10220 EASTFIELD RD

# CERTIFICATE OF COMPLETION/OPERATION PERMIT

# INSTALLATION, CONSTRUCTION, ALTERATION, AND/OR REPAIR APPROVAL

# PROPOSED PLOT PLAN

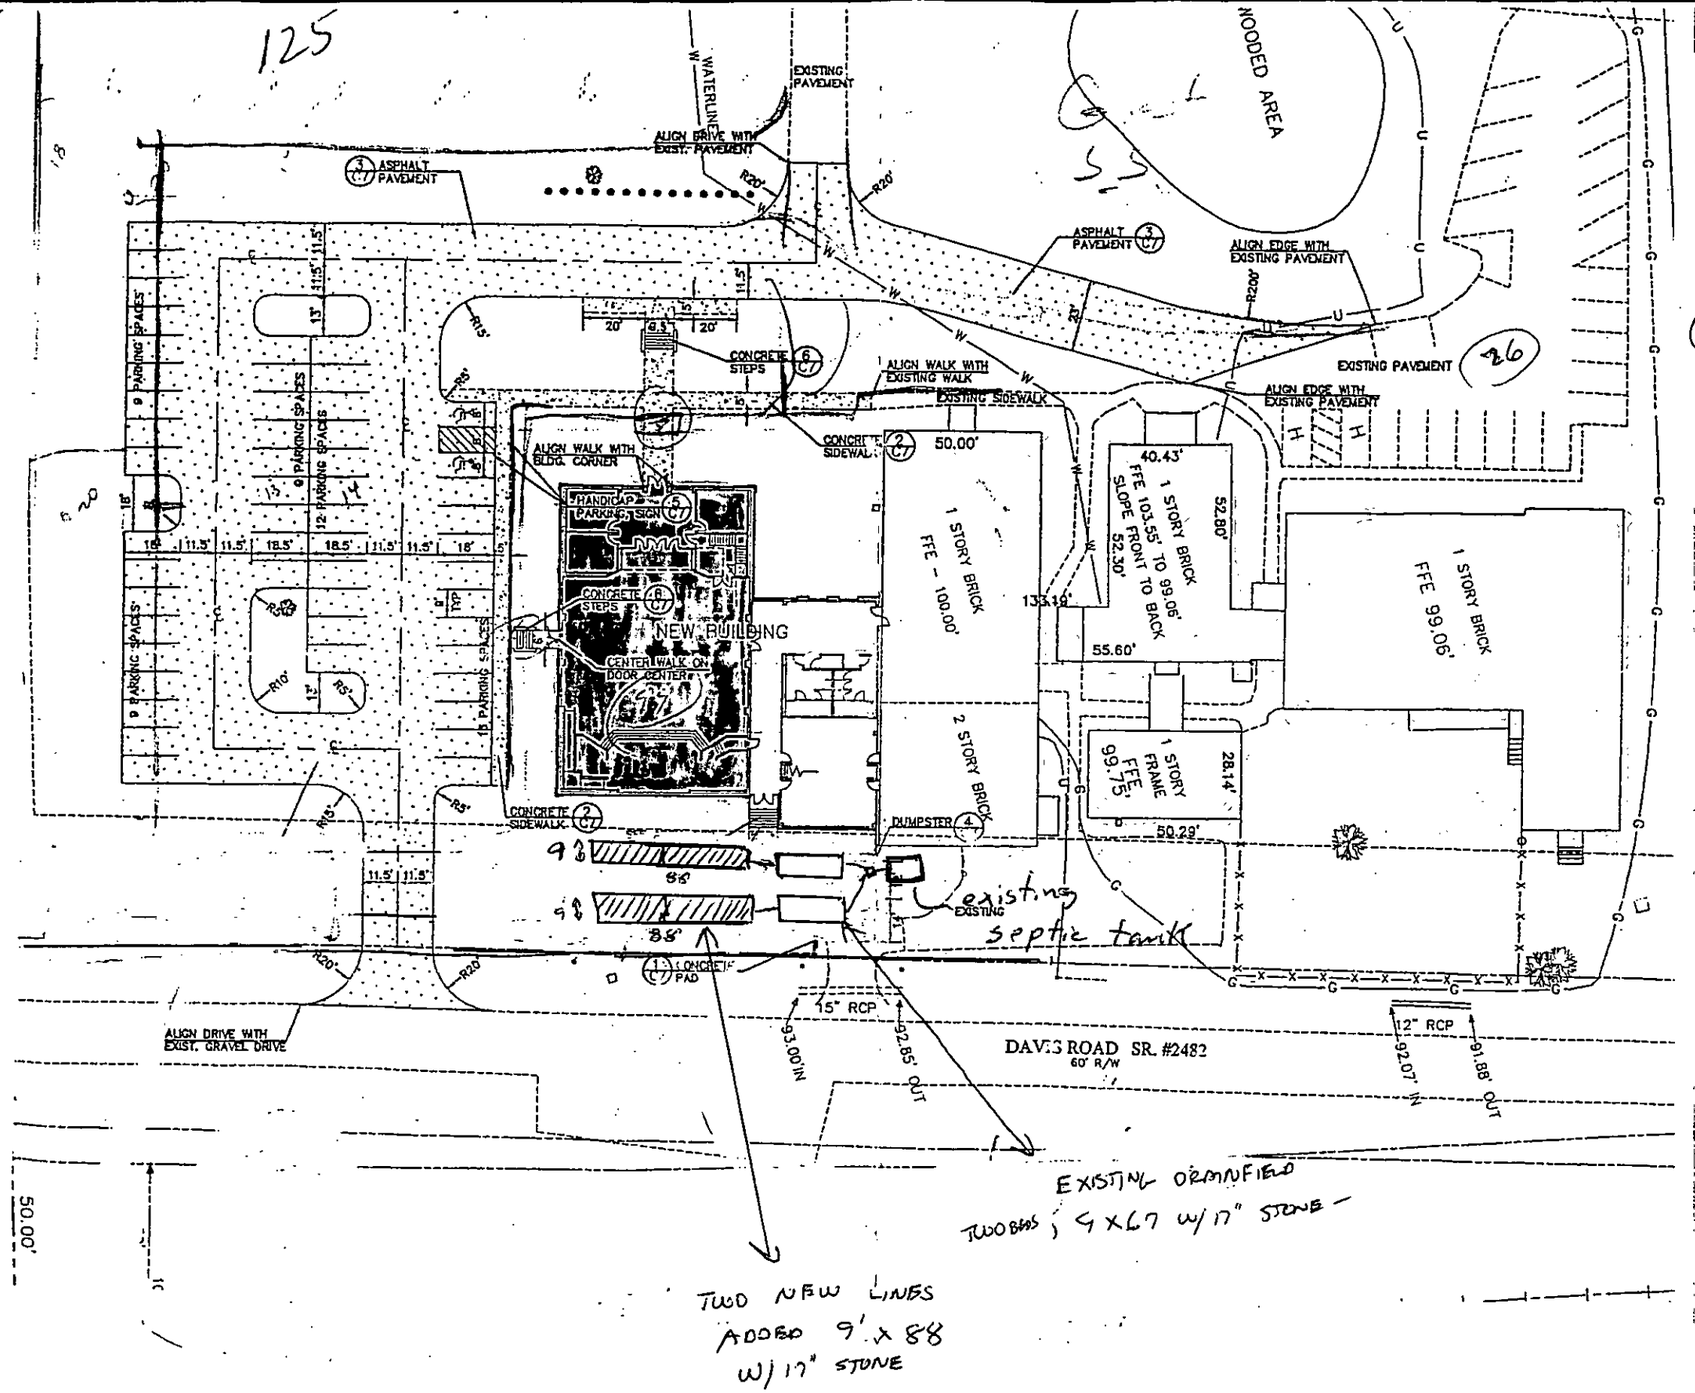
(1) THIS IS THE PLOT PLAN SHOWING THE ALTERATION FOR THE NEW SANCTUARY ADDITION.

(2) ACTUAL SANCTUARY SEATING TO BE 280 SEATS W/ NO KITCHEN FACILITIES. 880 SEATS @ 3 g/SEAT = 840 gpd.

840 ÷ .3 = 2800 SFT ÷ 8 = 933 TOTAL LINEAR FEET. WITH 400 EXISTING FEET OF DRAINLINE, IT WILL BE NECESSARY TO ADD 2 BEDS 9'X 88' W/ 19" STONE.

(3) CONTRACTOR TO TIE INTO EXSTING DRAINFIELD VIA STEP DOWN/ SPILL OVER.

(4) EXISTING TANK TO BE PUMPED AND "T" CHECKED.

(5) EXISTING DRAINLINES LEVEL.

(6) LOCATE ALL PARTS OF SEPTIC SYSTEM 100' FROM ALL WELLS.

# SITE PLAN

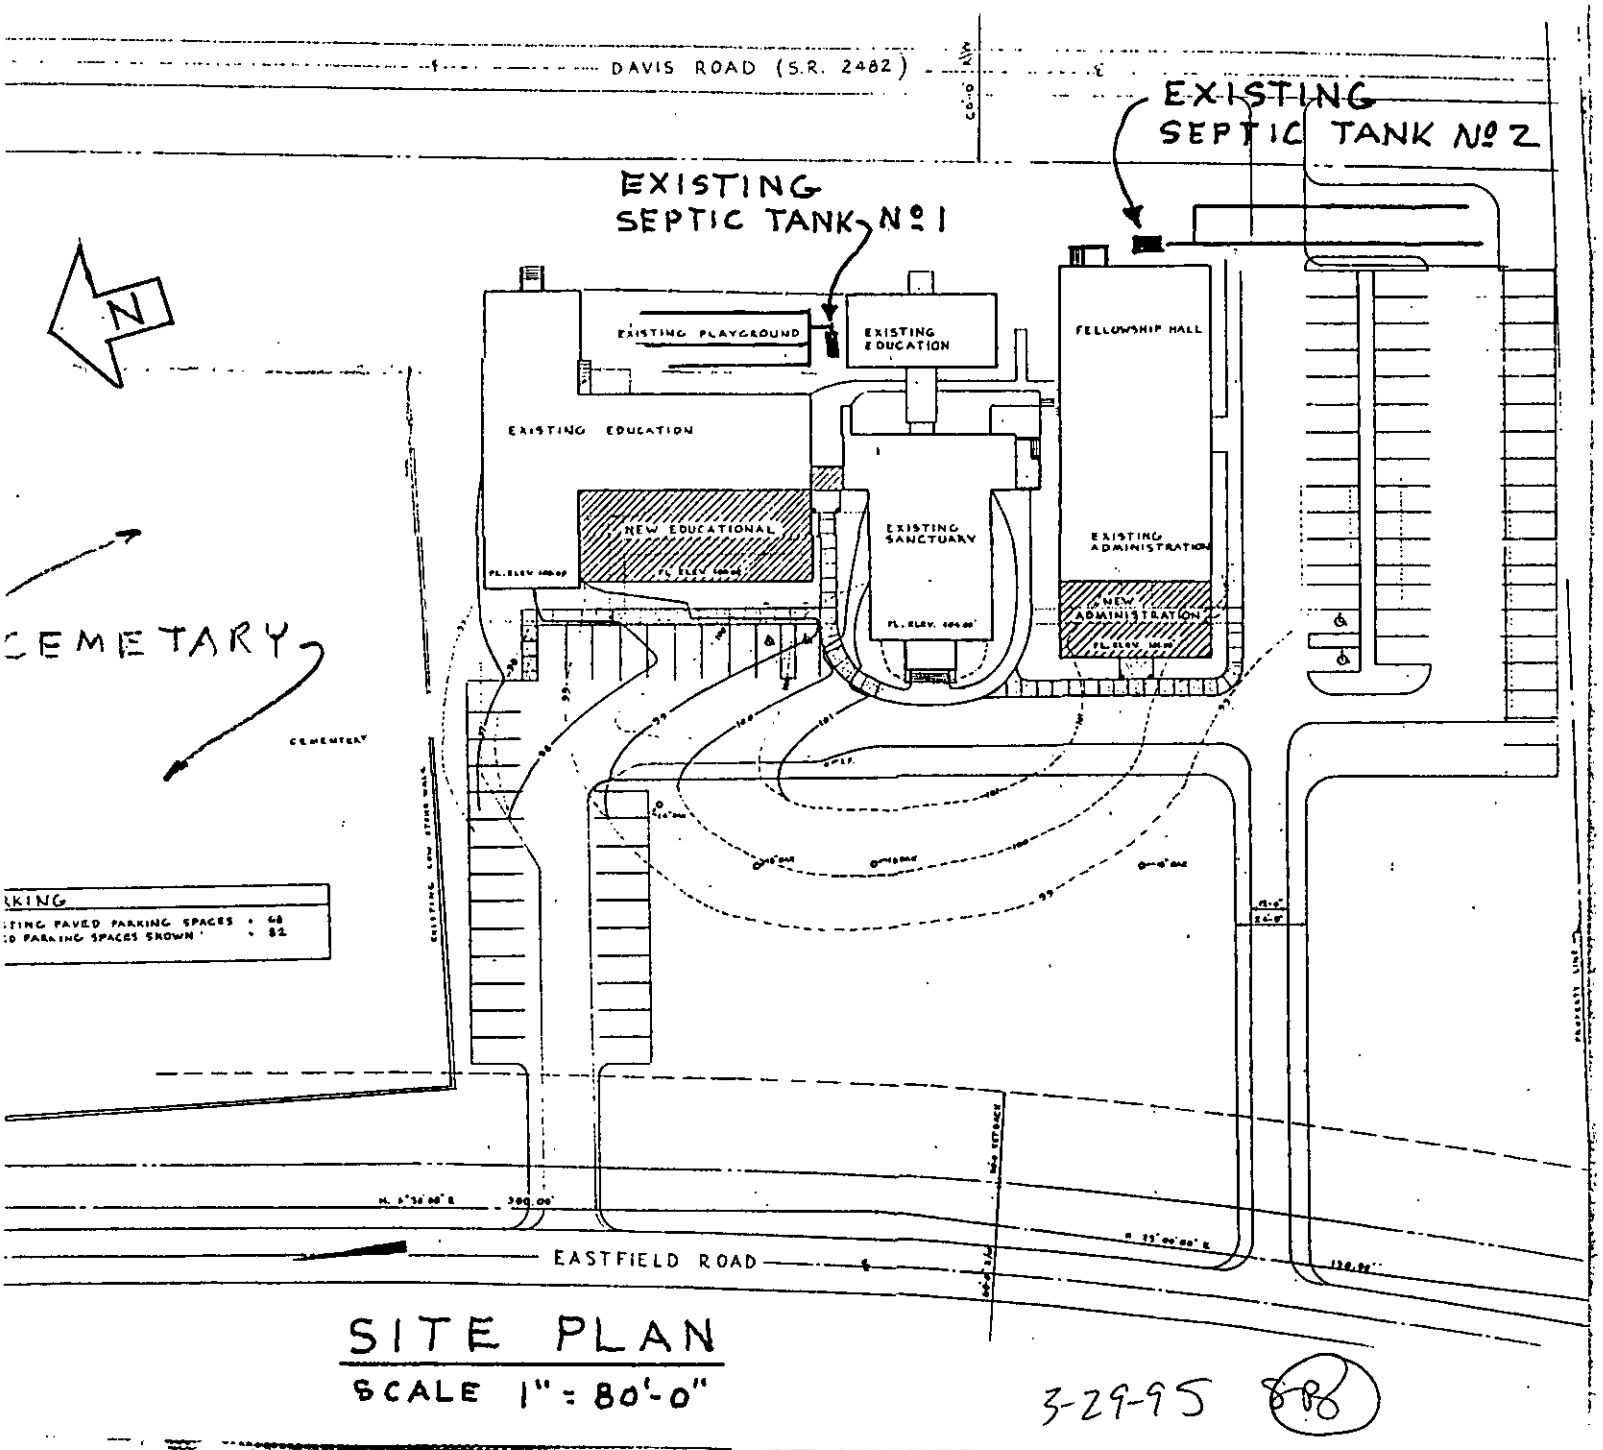
NOTES TO HEALTH DEPARTMENT AGENT

1. Educational Building addition - Number of people Sunday School only = 75.
2. Administration building addition - (Office's only) Number of people to occupy the office = 5.
3. The new addition to the education building will include the addition of seven (7) plumbing fixtures. Of the seven (7) fixtures (three) 3 are water closets and (four) 4 are lavatories.
4. There are no plumbing fixtures included in the administration addition.
5. We request permission to connect the new fixtures in the educational building into the existing septic tank No 1.

... use existing System & No change in number of people church seats during Sanctuary; Church does not have additional activities using facility.
